CEC Response

Spokes Planning Group

November 2017

TRO Plan 1

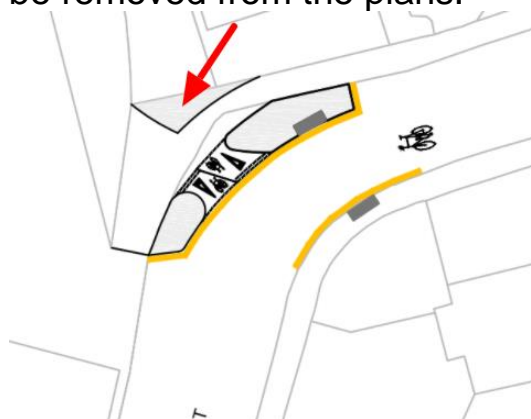
2. The designs should ensure that cyclists on the cycleway along Roseburn Terrace should have priority over motor traffic entering and exiting Roseburn Cliff. We consider that there should be a give way line at the junction between Roseburn Cliff and the cycleway and that there should be a raised table on Roseburn Cliff just before the junction with the cycleway as indicated in previous plans.

At the majority of side road crossings along Section 1 (Roseburn to Haymarket), 'continuous footway' crossings will be used. This will give priority to both pedestrians and cyclists. A continuous footway crossing will be introduced at the Roseburn Cliff junction.

These side road crossings will have give-way markings as suggested, raised tables to slow motor vehicles, and other means of highlighting visually the priority for pedestrians and cyclists.

Once the full design specification for continuous footway crossings has been finalised and agreed, all such crossings along the CCWEL route will be updated in the design drawings.

It is yet to be confirmed whether signs (either temporary or permanent) will be utilised at these locations. This decision will be taken at the final design stage.

TRO Plan 2

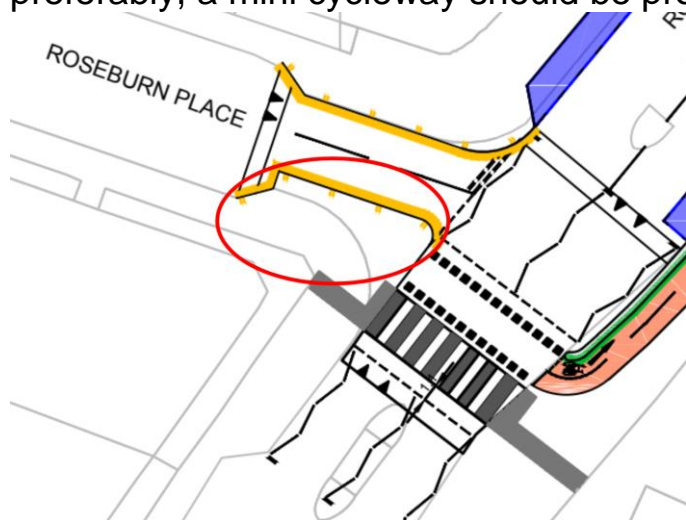
2. Earlier communication from the Active Travel Team (July 2017) suggested that the access to the park would be 4.5 m. The current plans do not give measurements, but the proposed entrance/exit would seem to be much less than this. Given that a narrow space could create conflict between cyclists and pedestrians we consider that the 4.5m wide access should be retained.

3. Although there is a clear line of sight for cyclists exiting the park, cyclists crossing the road to enter the park can have their sight line obscured by parked cars on the bend at Roseburn Crescent. We consider that the double yellow line should be extended further round the bend in the road to prevent this.

The width of the park access/egress is 4.3m at its narrowest point.

The double yellow lines will be extended slightly to improve visibility.

TRO Plan 3

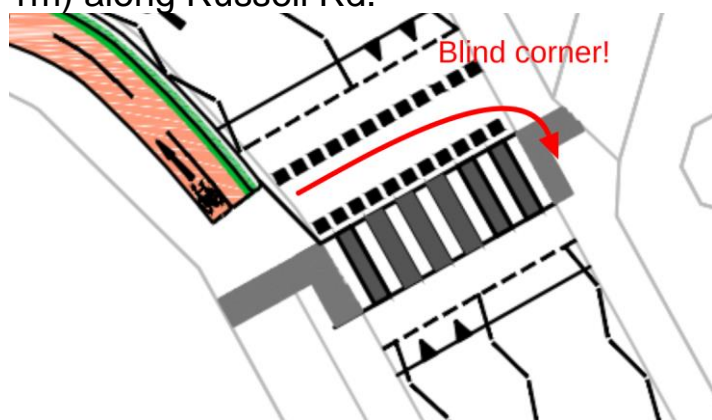
1. It is not clear how cyclists will get to and from Roseburn Place if travelling between Roseburn Place and the new cycleway running along Roseburn Street and into Russell Rd. Although there is a tiger crossing shown

across Roseburn Street itself this runs into an area of pavement on the Roseburn Place side. We consider that this area or pavement should be clearly designated for shared use by cyclists and pedestrians or, preferably, a mini cycleway should be provided on the pavement.

The footway in the area which you have highlighted will be designated as shared-use in the plans which are advertised for the Redetermination Order. Appropriate shared-use signage will also be provided, and consideration will be given to appropriate route direction signage. This will allow cyclists using the tiger crossing to join/leave the carriageway on Roseburn Place.

TRO Plan 6

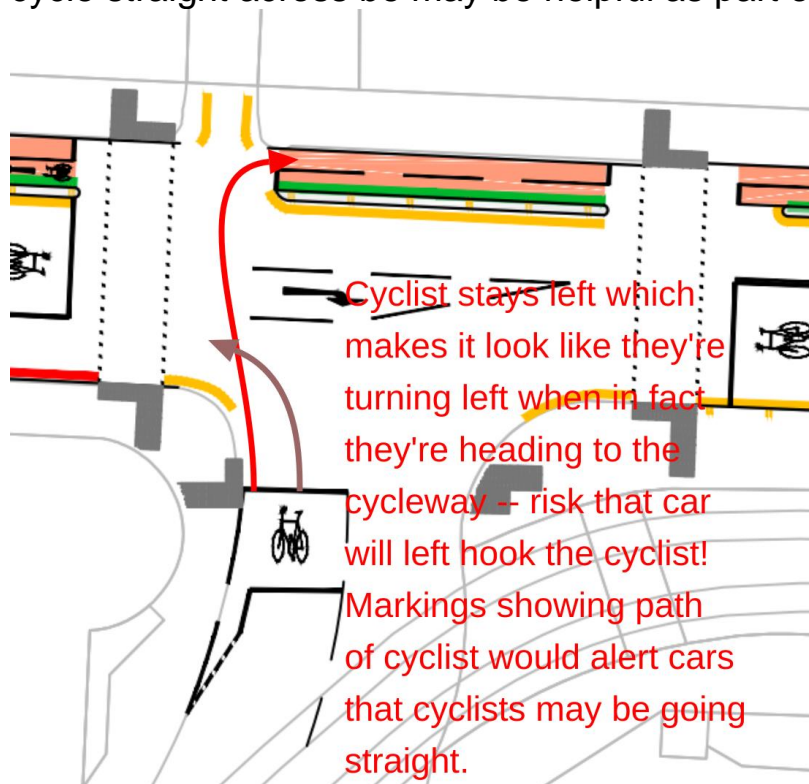
2. We are surprised to see that space has been allocated for short term parking (up to 2 hours between 8.30 am and 4.30 pm) from Monday to Saturday at the eastern end of West Coates. This overlaps with the operation of the bus lane and it seems contrary to the advice given to us in July that the stretch of cycleway between Wester Coates Rd to Magdala Crescent could not be widened to 2.5m (the normally minimal acceptable size for a 2 way cycleway) because of “heavy bus/coach flows in both directions”. Given this assessment, how is it possible to now provide additional parking spaces?

This is an error in the plans – the timings for Greenway parking bays will be corrected so as not to conflict with the bus lane operating hours.
